5020 N. INTERSTATE

APPLICANT APPEAL 1

NEIGHBORHOOD APPEAL

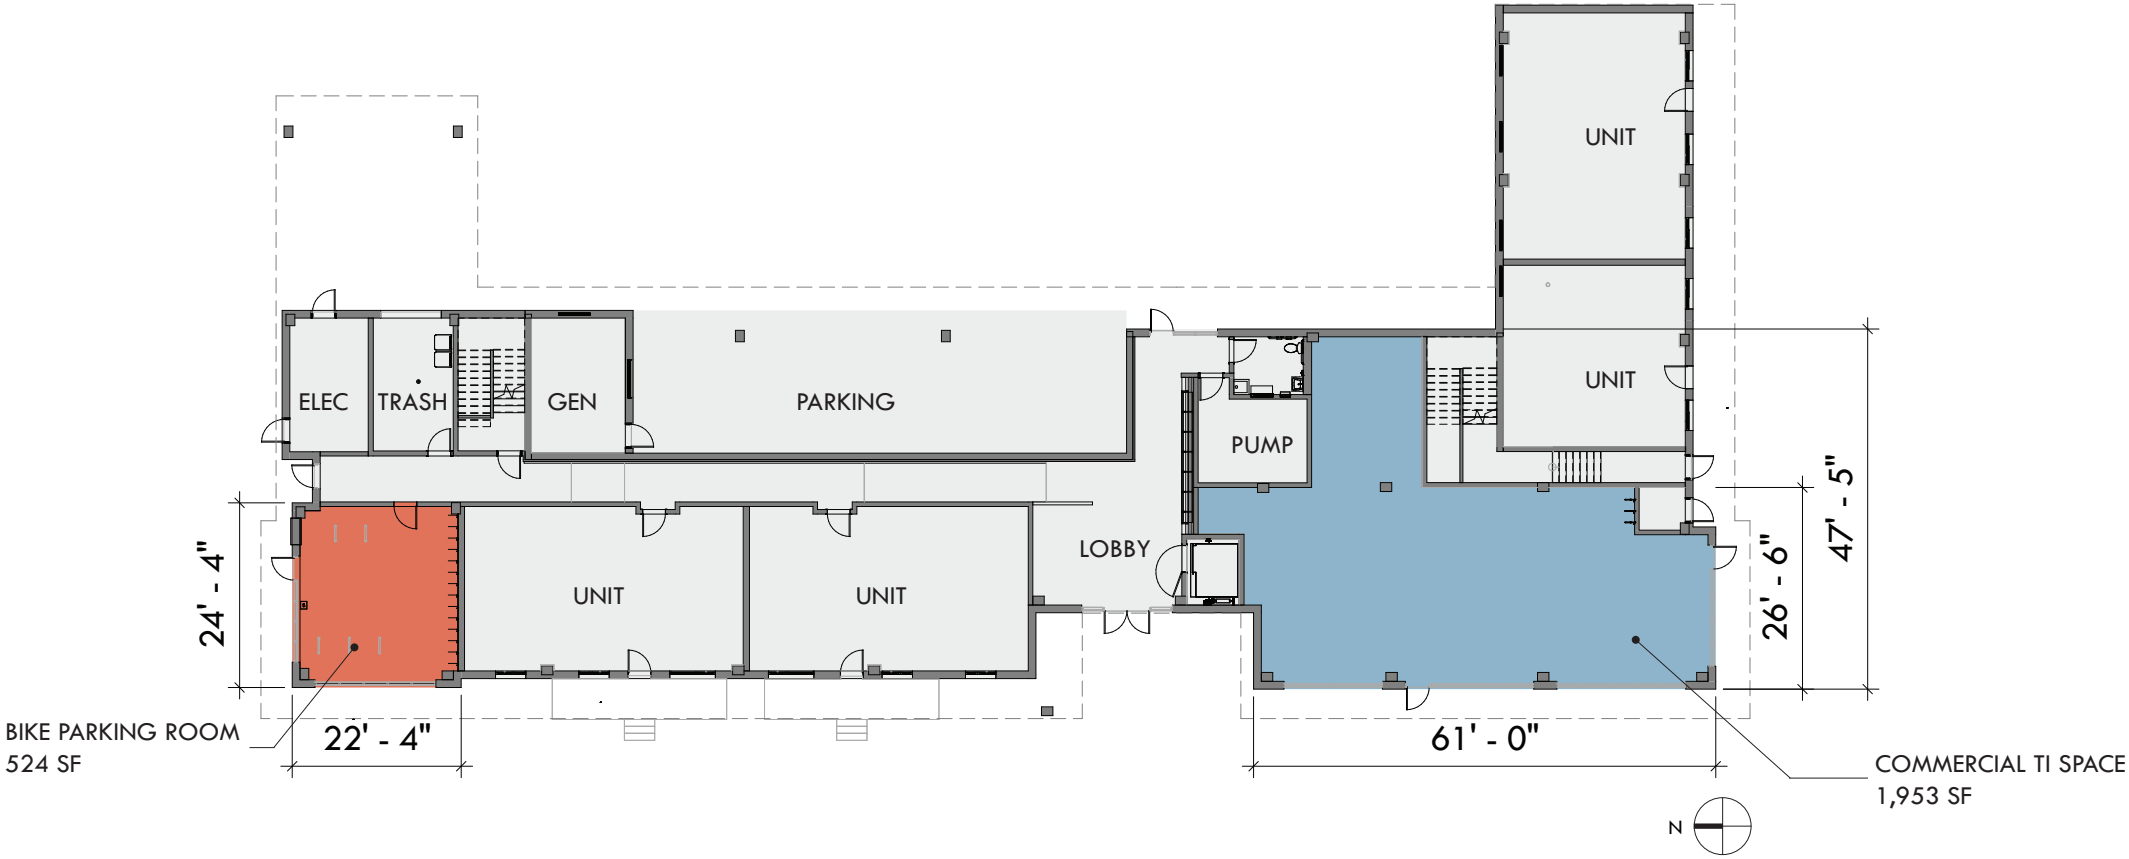
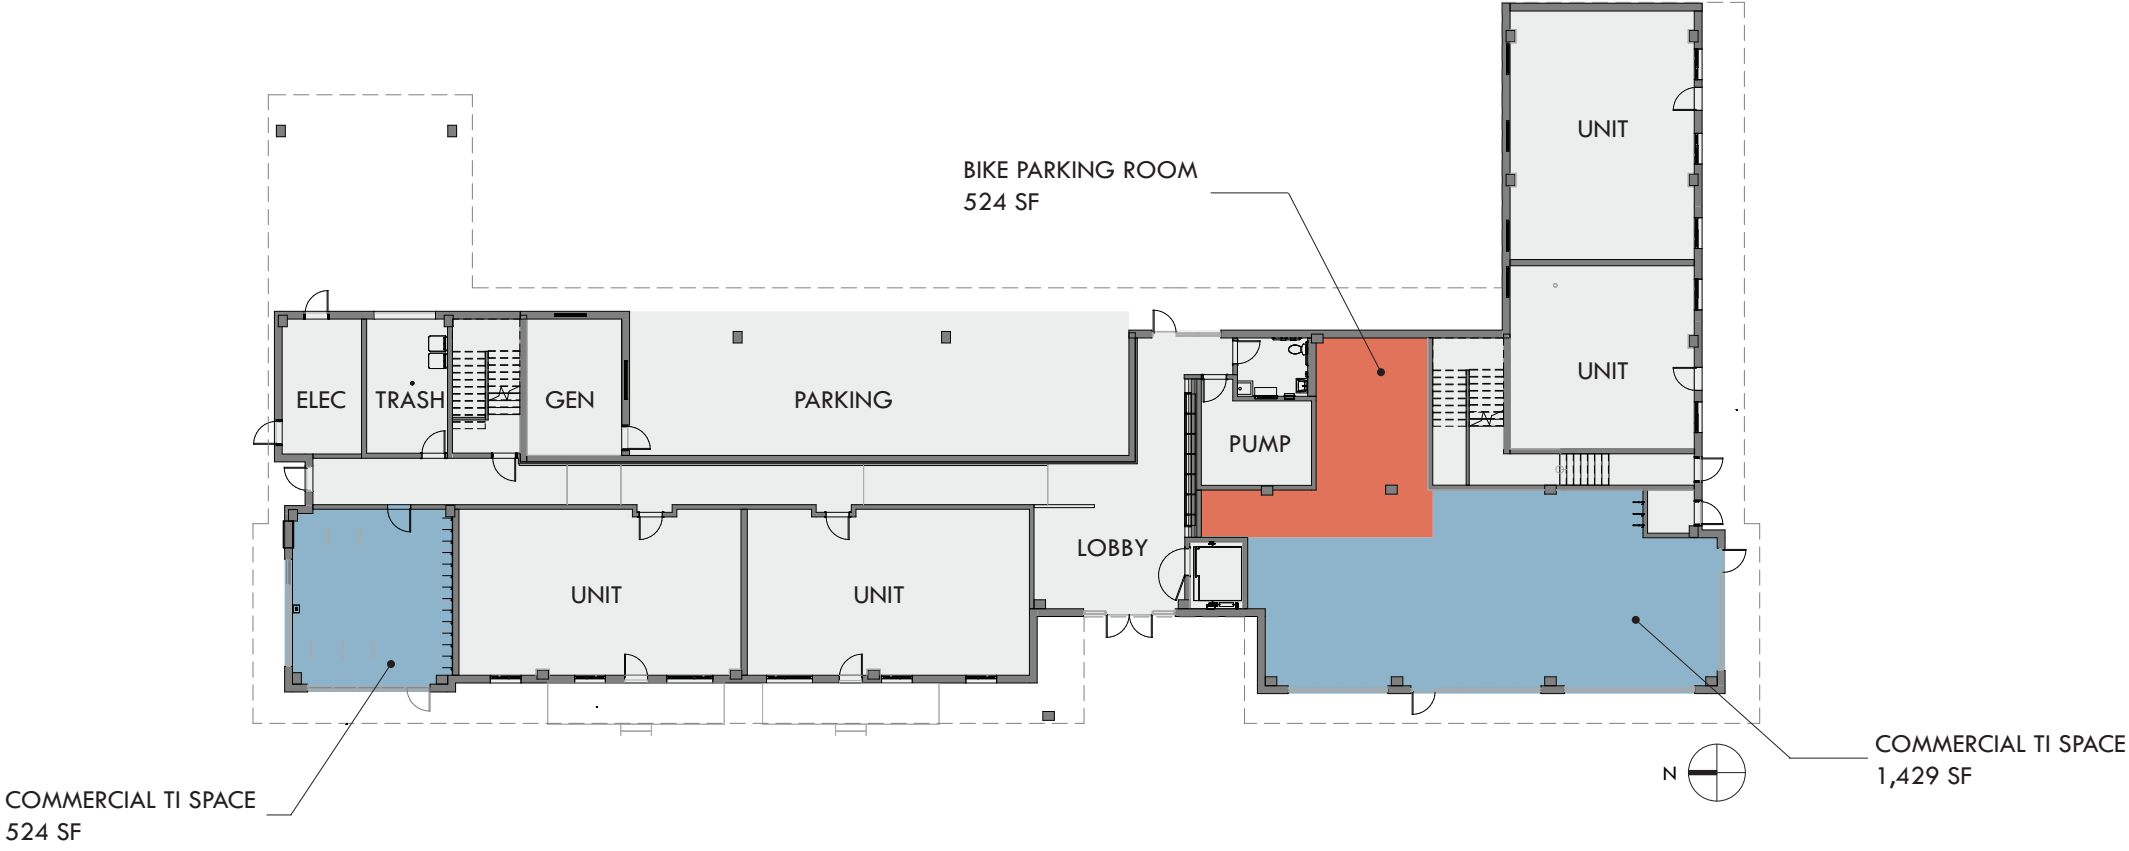
CONDITION OF APPROVAL 1

“THE PROPOSED BIKE STORAGE ROOM AT THE NORTHWEST CORNER OF THE BUILDING SHALL BE CONVERTED INTO A GROUND FLOOR COMMERCIAL USE SPACE (OR OTHER ACTIVE USE AS LISTED IN THE “M” OVERLAY ZONE, SECTION 33.415.200); THAT BIKE PARKING THAT IS CURRENTLY PROPOSED IN THIS ROOM SHALL BE LOCATED EITHER IN INDIVIDUAL UNITS OR IN THE ORIGINAL LOCATION SHOWN IN EXHIBIT A.18, OR IN SIMILAR LOCATION TO THE SOUTH OF THE LOBBY ALONG THE EAST ELEVATION OF THE BUILDING; AND THAT A STOREFRONT ENTRY DOOR SHALL BE PLACED ON THE N. INTERSTATE AVE. FRONTAGE OF THE NORTHWEST CORNER COMMERCIAL SPACE.”

- RESIDENT LONG-TERM PARKING ROOM LOCATED AT GROUND FLOOR WITH CONVENIENT AND DIRECT ACCESS TO STREET FROM N. WEBSTER & N. INTERSTATE
- STOREFRONT GLAZING AT BIKE PARKING ROOM ALLOWS FOR VIEWS INTO THE BUILDING AND ACTIVITY OF PEOPLE COMING AND GOING BY BIKE
- BIKE ROOM PROVIDES 25 LONG-TERM SPACES FOR BIKE PARKING WITH A VARIETY OF HORIZONTAL AND VERTICAL WALL MOUNT RACKS
- INCLUDES SPACE FOR BIKE WORK STAND AND BIKE PUMP FOR RESIDENTS TO PERFORM BASIC MAINTENANCE
- ROOM SECURED BY ACCESS CONTROL DOORS AND LOCATION IN HIGH VISIBILITY AREA BEHIND STOREFRONT GLAZING FACING N. WEBSTER AND N. INTERSTATE

- RELOCATE BIKE ROOM TO CREATE COMMERCIAL SPACE IN NW CORNER:
- MOVES BIKE ROOM TO LOCATION ADJACENT TO ENTRY LOBBY; TAKES SPACE AWAY FROM LARGER, MORE FLEXIBLE COMMERCIAL SPACE ON SW CORNER, OR
 - MOVES 25 BIKE PARKING SPACES FOR RESIDENTS FROM DEDICATED BIKE ROOM TO UNITS. THIS OPTION IS NOT POSSIBLE BECAUSE THE LIMITED SPACE IN FAMILY SIZED UNITS DOES NOT ALLOW FOR IN-UNIT BIKE PARKING
 - CREATES SEPARATE COMMERCIAL SPACE AT NW CORNER THAT WILL BE LIMITED IN USE BY ITS SMALL SIZE, ESPECIALLY ONCE RESTROOM AND BIKE PARKING STORAGE REQUIREMENTS ARE MET
 - ENTRY DOOR MOVED TO WEST ELEVATION REQUIRES 9' LONG RAMP FOR SIDEWALK GRADE TO MEET FF GRADE IN BUILDING
